Process/Product Change Notification Form

PCN No:	68 Rev A02
Notice Date:	30 September 2023
Title:	Qualification of UBM Plating process

Products Affected: All WLCSP (Wafer level CSP) products (Please refer to the table in description of change section)

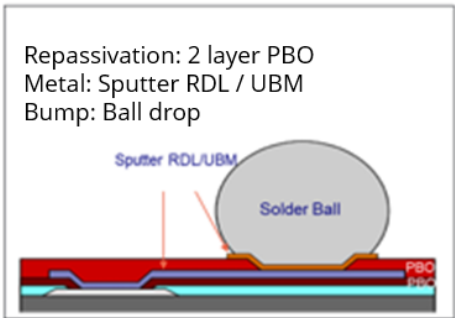
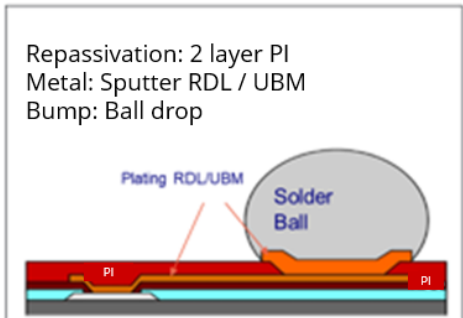
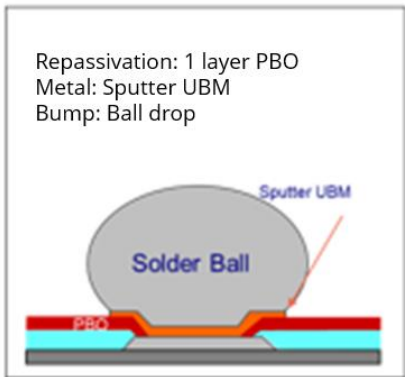
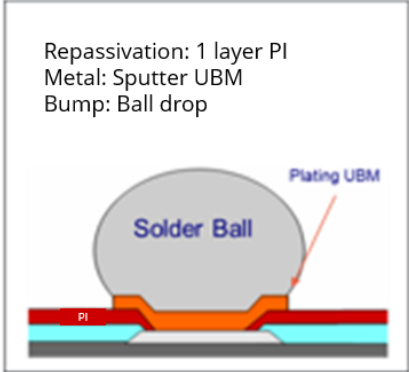
- Niv/Cu Etchant Surfactant is used for UBM etching during bumping using the sputtering process.
- The sub-supplier will discontinue this chemical. No other supplier is found to offer the same chemistry.
- Assembly supplier (ASE) is moving to the plating process for both UBM and RDL Cu plating.
- Passivation material is changed to PFAS-free material (BL301) for both CMOS and MEMs wafers.
- Details of the change are compared as shown below,

Device Type	AS-IS (SPUTTER RDL/UBM)	TO-BE (PLATED RDL/UBM)
SIE 2P2M	<p>Repassivation: 2 layer PBO Metal: Sputter RDL / UBM Bump: Ball drop</p> 	<p>Repassivation: 2 layer PI Metal: Sputter RDL / UBM Bump: Ball drop</p> 
SIE 1P1M	<p>Repassivation: 1 layer PBO Metal: Sputter UBM Bump: Ball drop</p> 	<p>Repassivation: 1 layer PI Metal: Sputter UBM Bump: Ball drop</p>
